November 4, 1999

**Re: Addendum No. 1 to Removal Action Work Plan -
Upper ½-Mile Reach of the Housatonic River
General Electric Company, Pittsfield, Massachusetts**

This Addendum No. 1 presents information associated with construction and restoration activities in the Upper ½-Mile Reach of Housatonic River adjacent to the Lyman Street Area (as defined in the Consent Decree). This information is presented on two attached figures -- Figure 4-4 and Figure 7-1D. The first figure (Figure 4-4) has been revised to identify the lateral limits of excavation associated with the installation of barrier sheeting at the Lyman Street Area and the location of several removal/restoration cross-sections within the excavation area. In addition, as depicted on Figure 4-4, a continuous layer of rip-rap along the toe-of-slope between polygons SL0229 and SL0170 has been added. The second figure (Figure 7-1D) depicts cross-sections (Sections V-V' through AA-AA') indicated on Figure 4-4 and identifies the limits of excavation and the proposed restoration activities for those areas.

FIGURE
7-1D

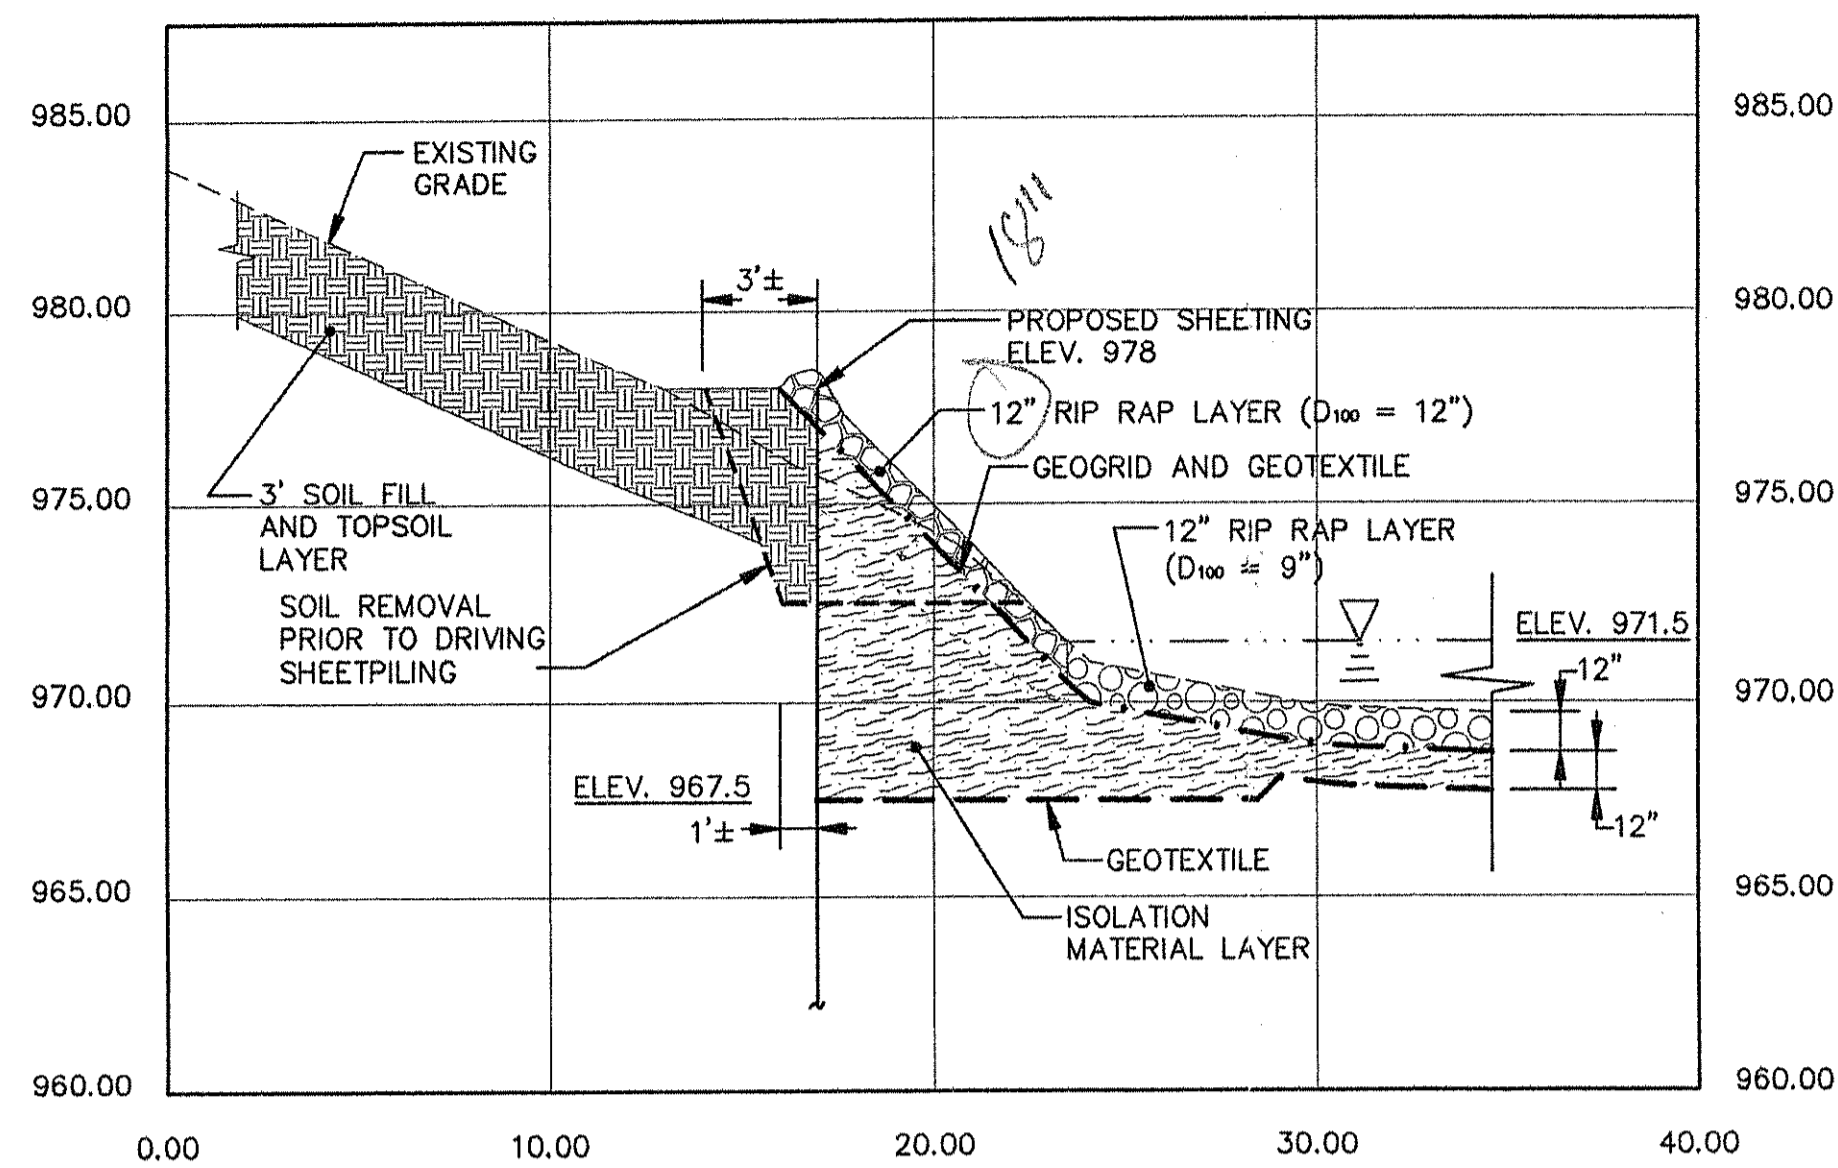
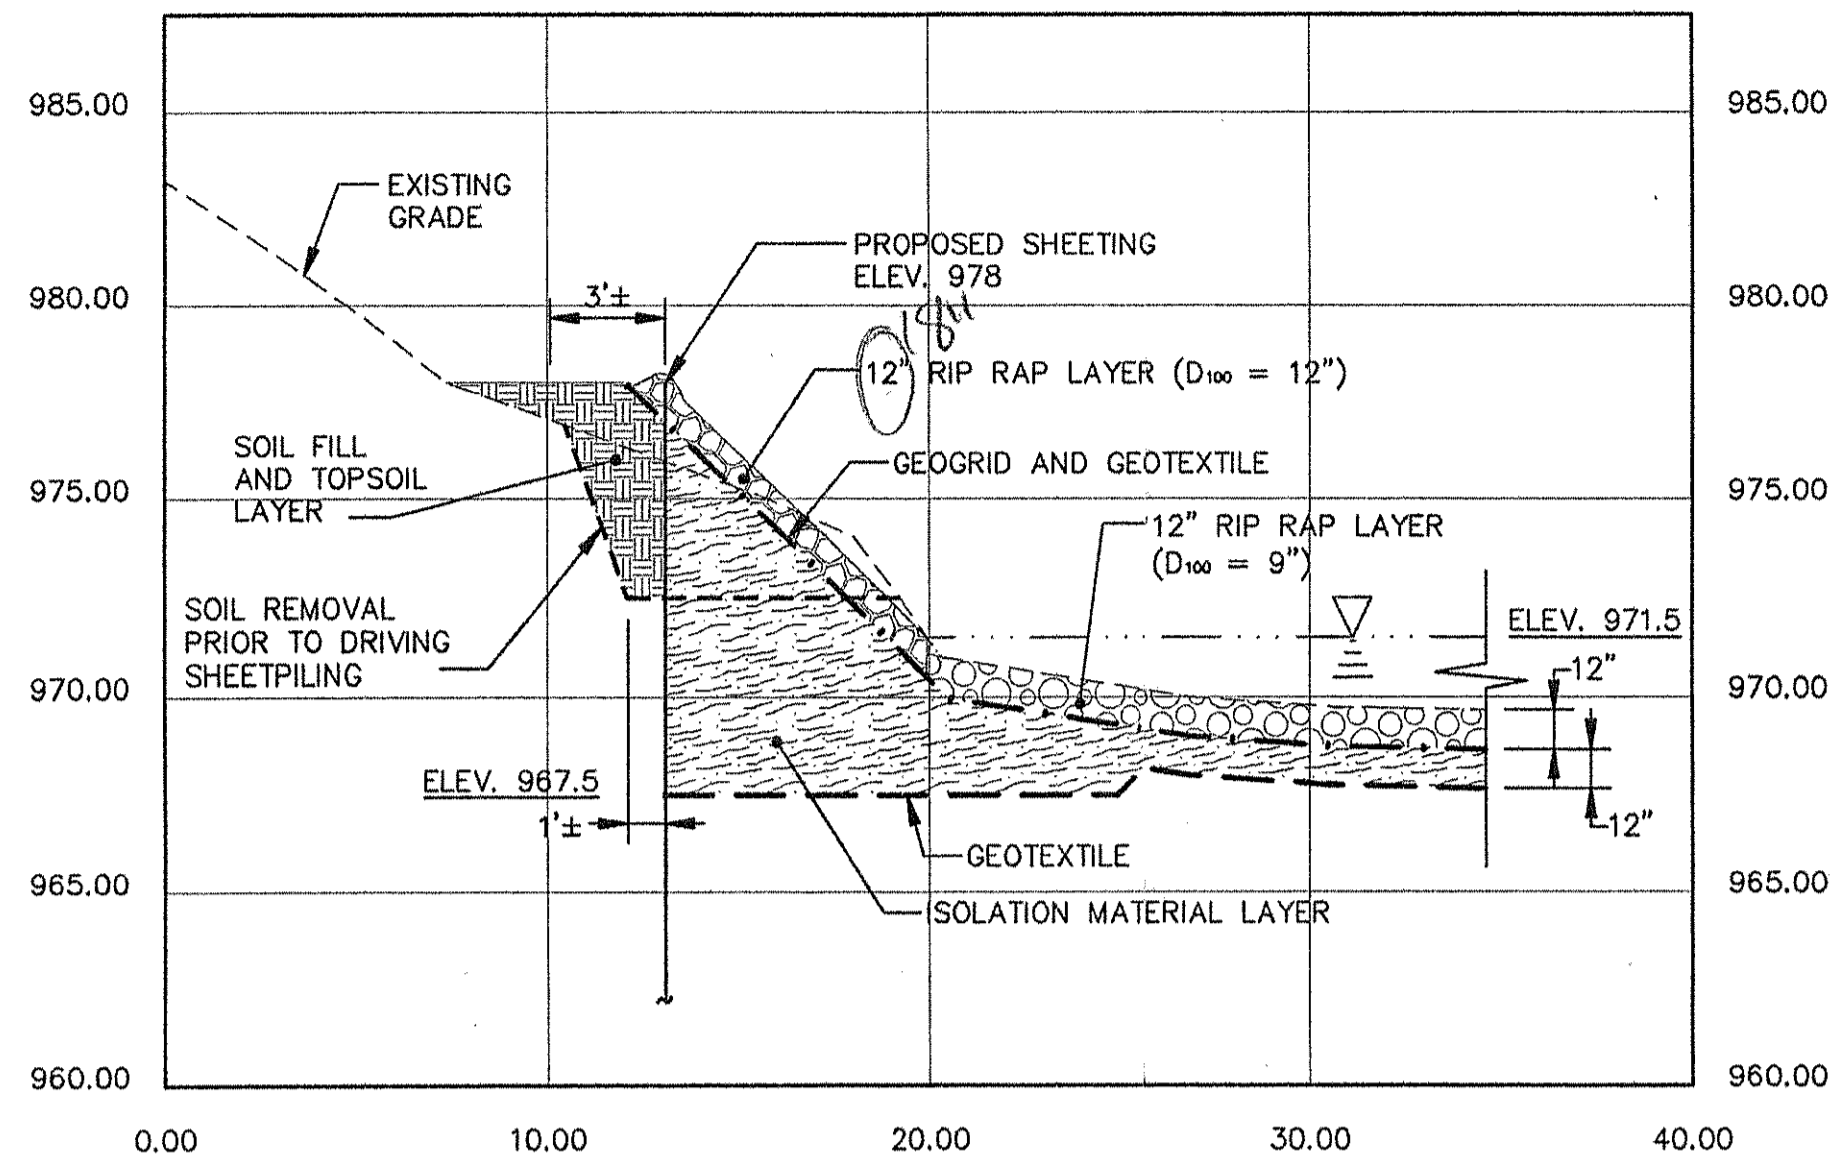
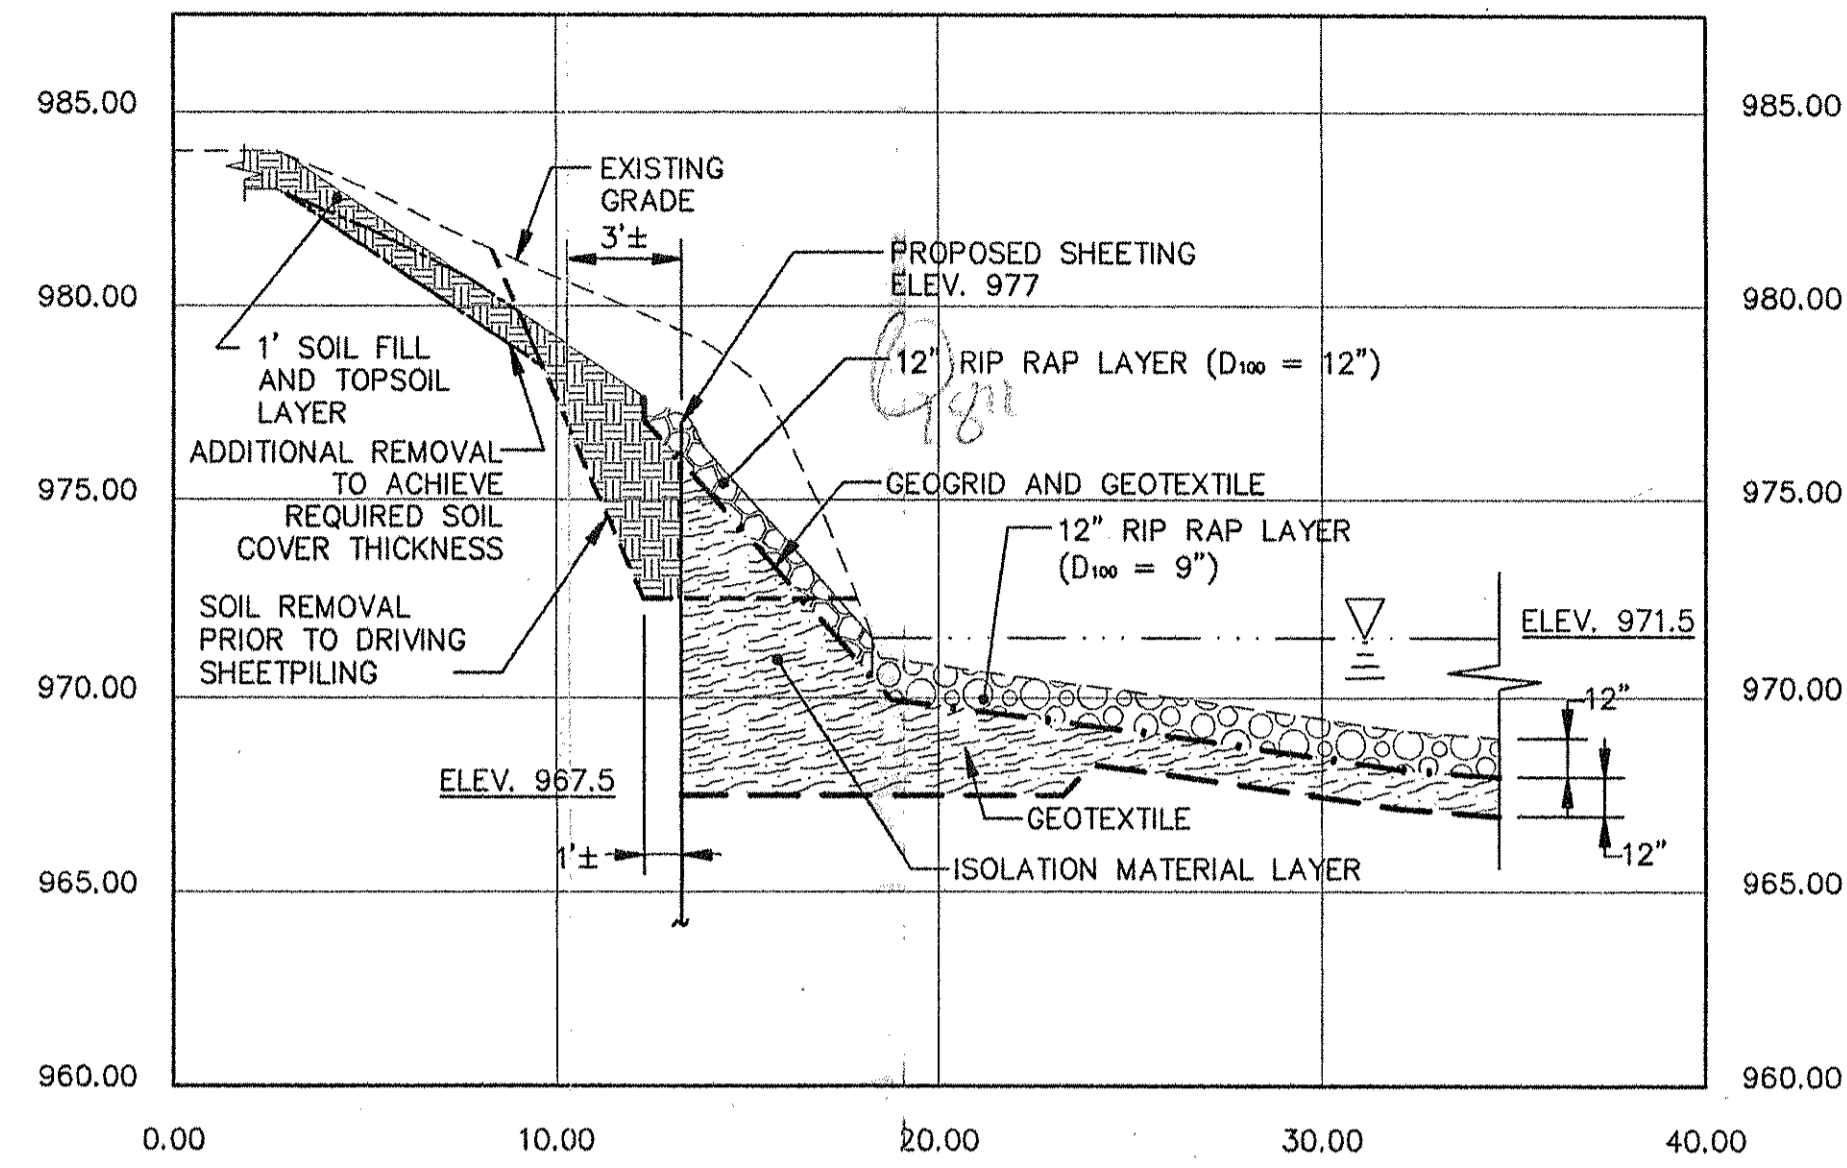
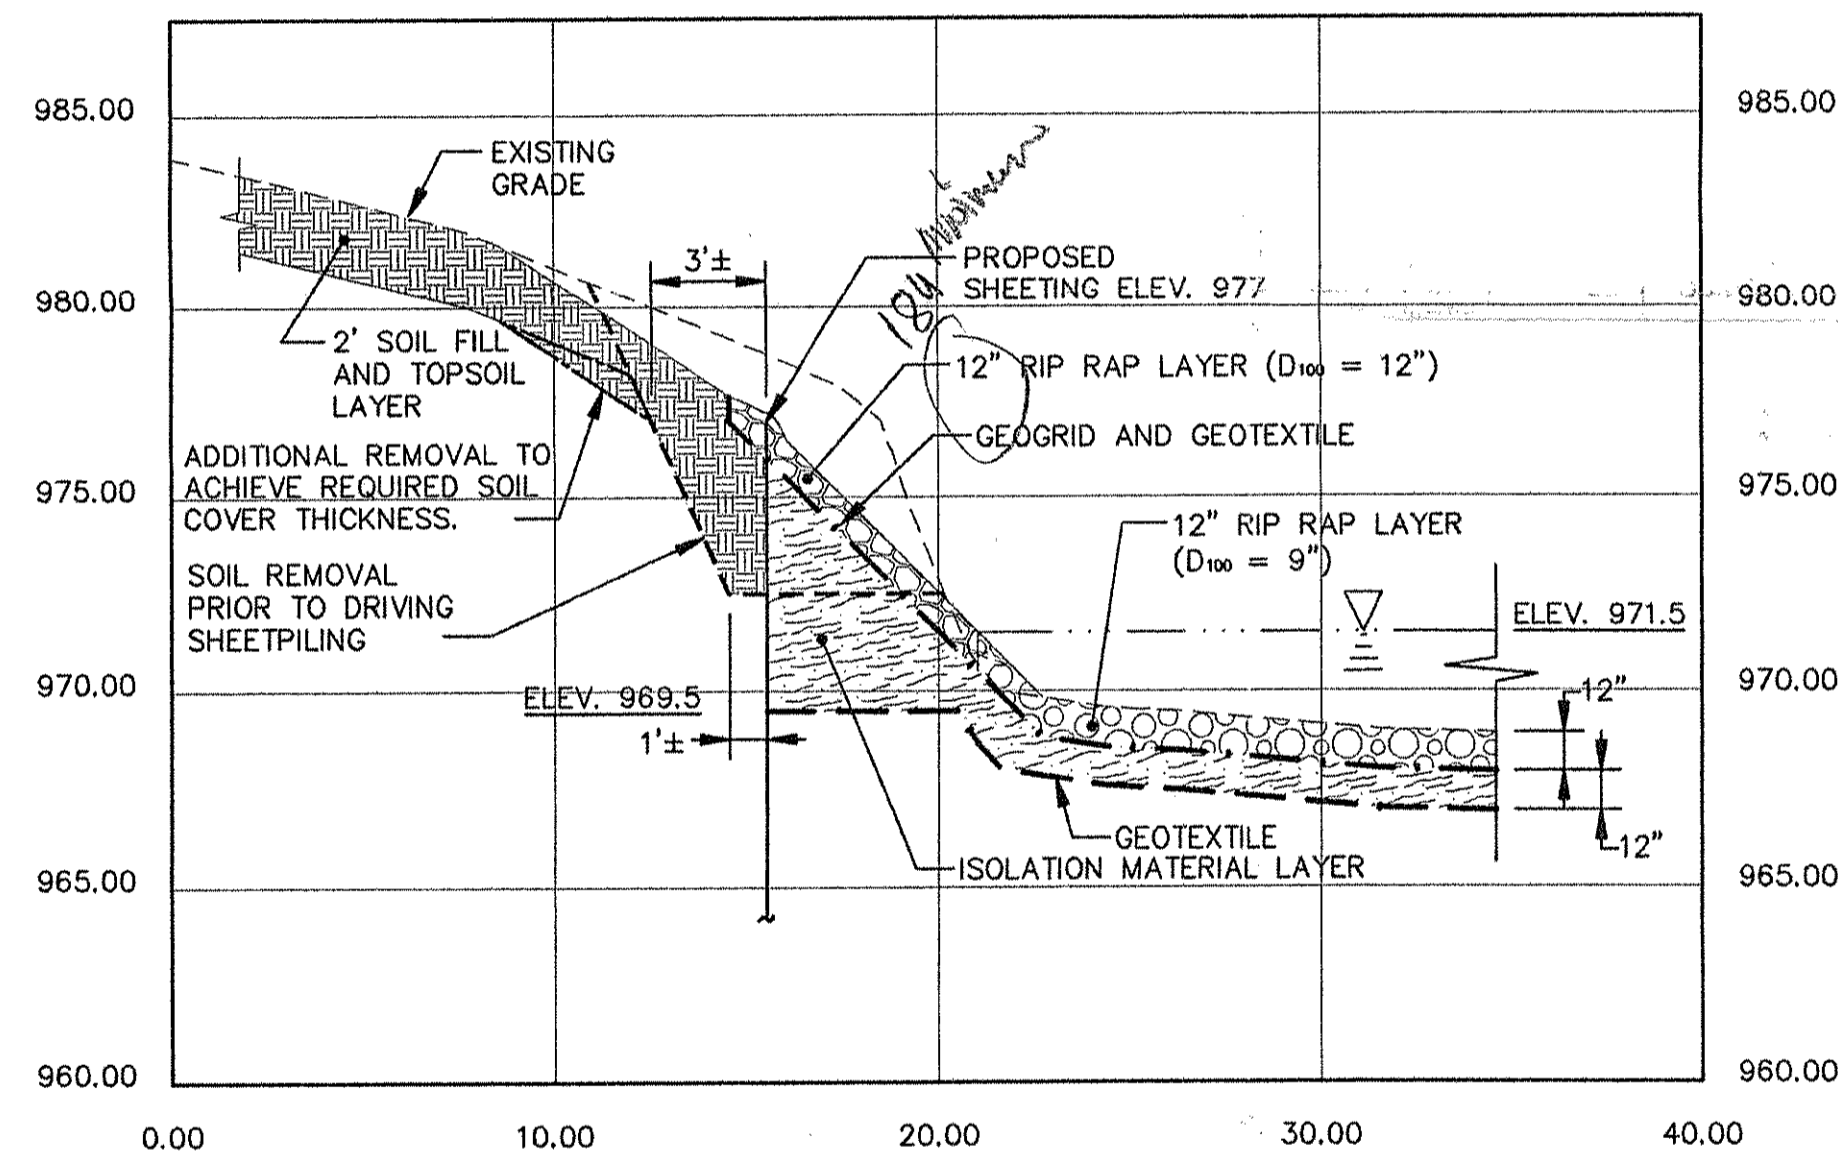
No.	Date	Revisions
1	11/4/99	ADDENDUM No. 1 - SECTIONS V-V' THROUGH AA-AA'

1. THE LOCATION OF THE SHEETPILE SHOWN IS APPROXIMATE AND WILL BE FIELD ADJUSTED BASED ON TOPOGRAPHIC CONDITIONS TO CREATE AN APPROXIMATE SLOPE OF 1H:1V FOR THE RESTORED BANK FROM THE RIVER'S EDGE TO THE TOP OF SHEETING.
